GUIDANCE FOR THE SURVEY AND CONSTRUCTION OF STEEL SHIPS

Fire Protection, Detection and Extinction

AMENDMENT NO.2

Notice No.94 15th October 2010

Fig. R18.2.1-34 ~~W~~Example of winching area

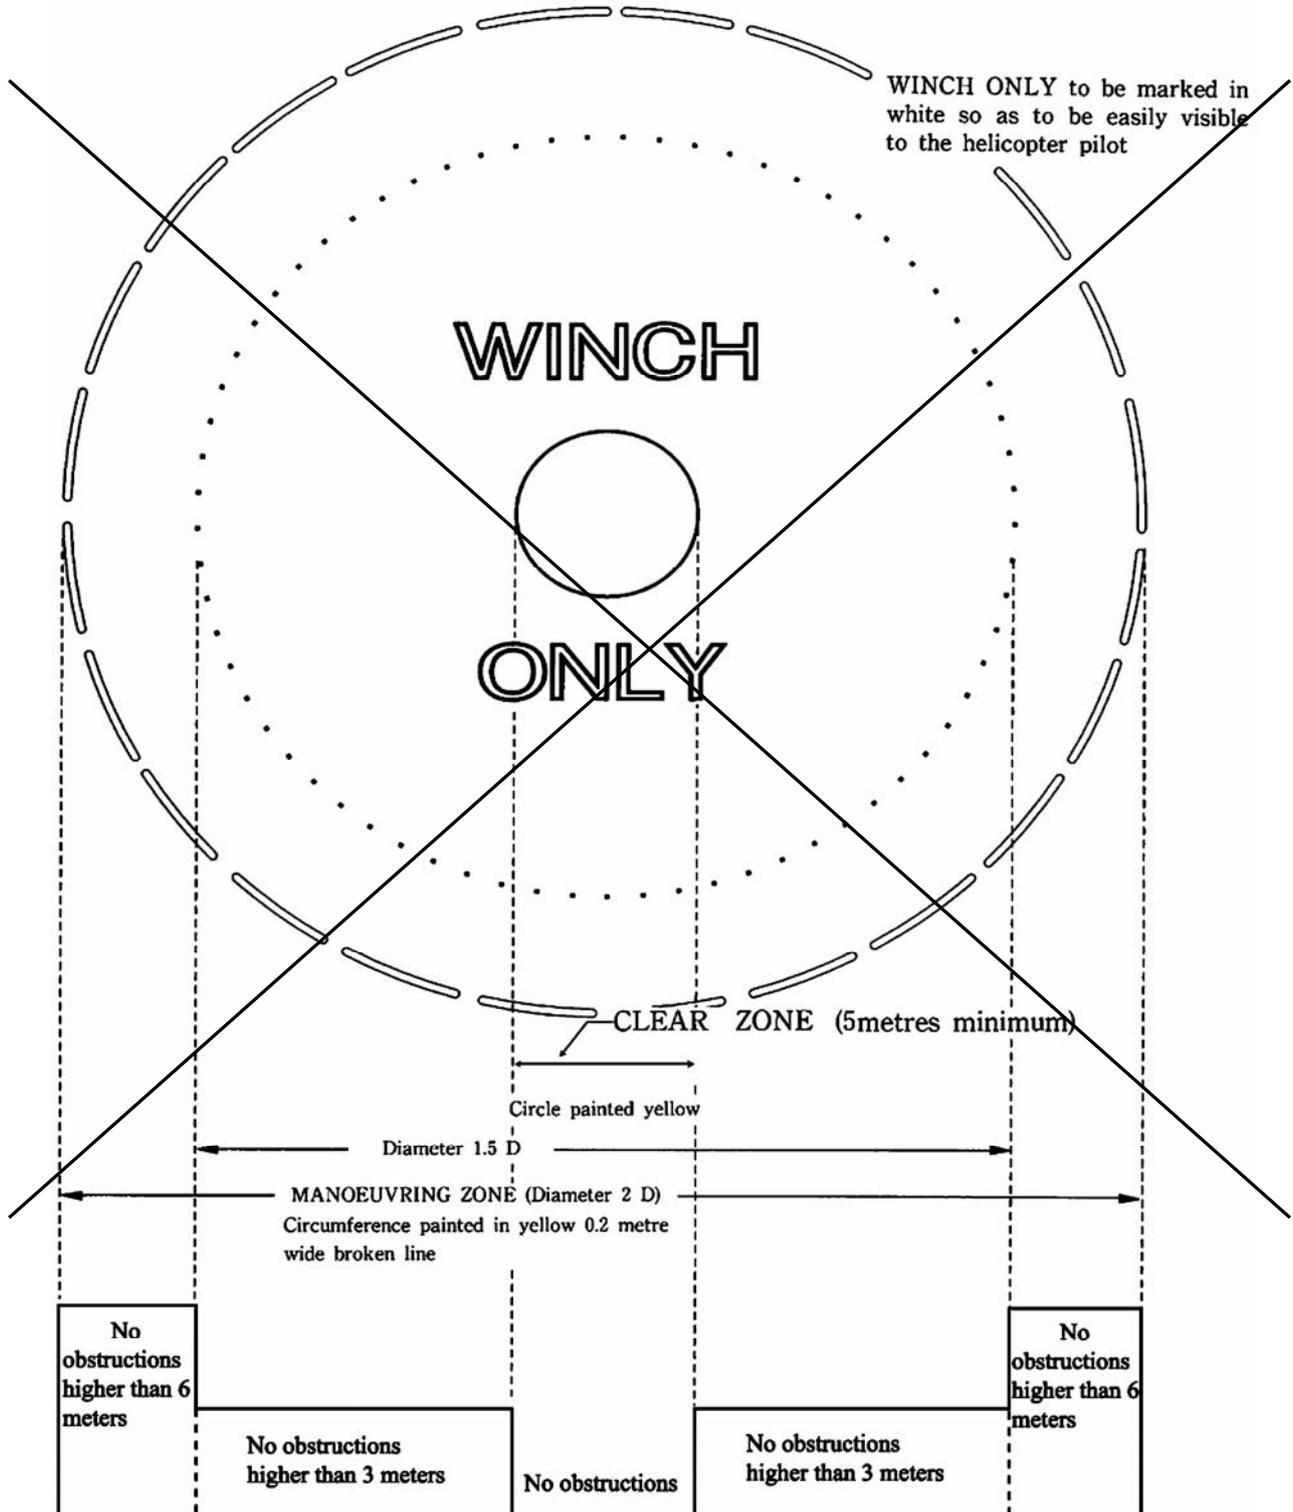
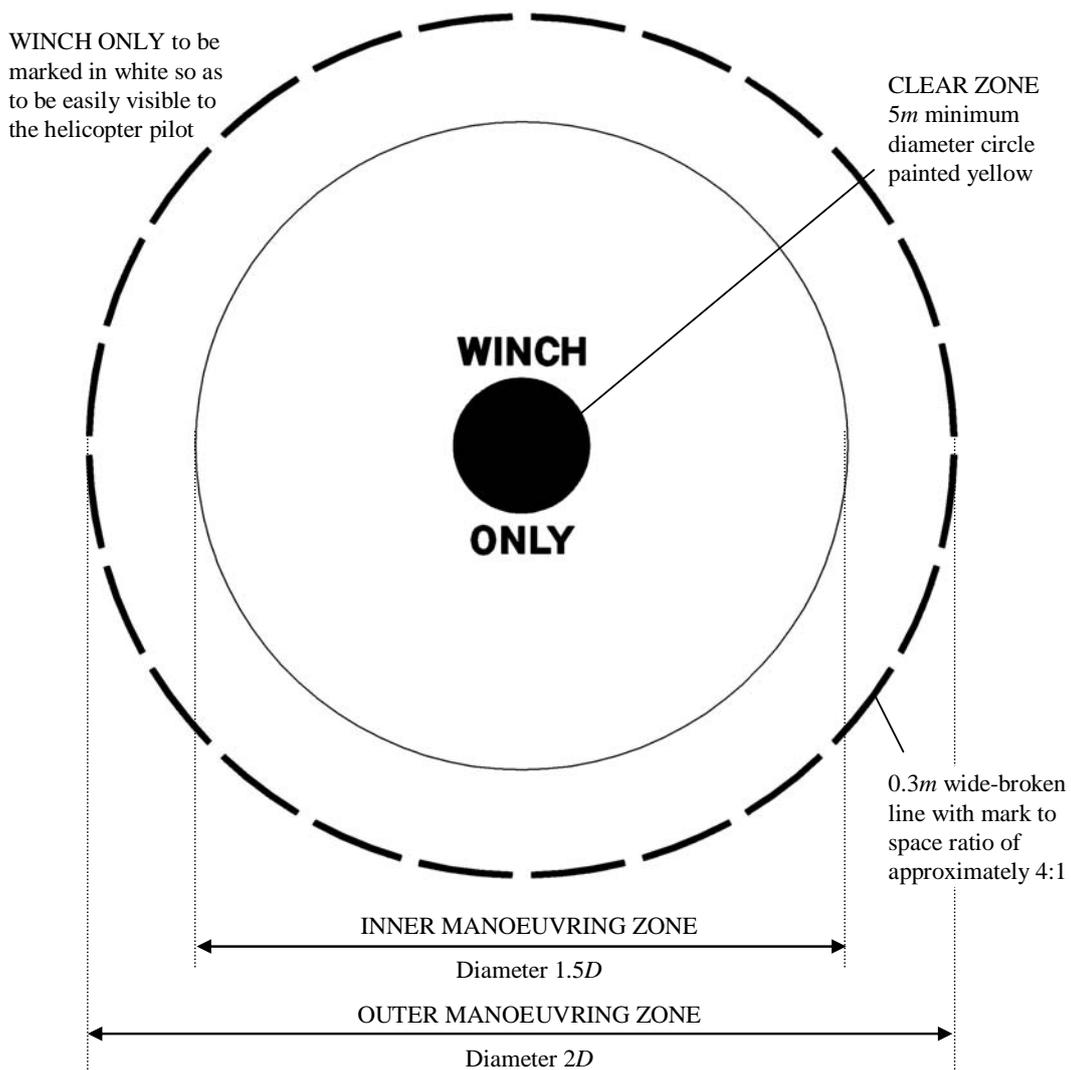
Fig. R18.2.1-4 has been amended as follows.

1. The perimeter of the outer portion of the manoeuvring zone is to be marked with a conspicuous broken yellow line.
2. The inner portion of the manoeuvring one may be indicated by painting a thin white line that is no more than 0.1m wide.
3. Ideally, the words "WINCH ONLY" is to be painted in 2m - 5m high white characters.
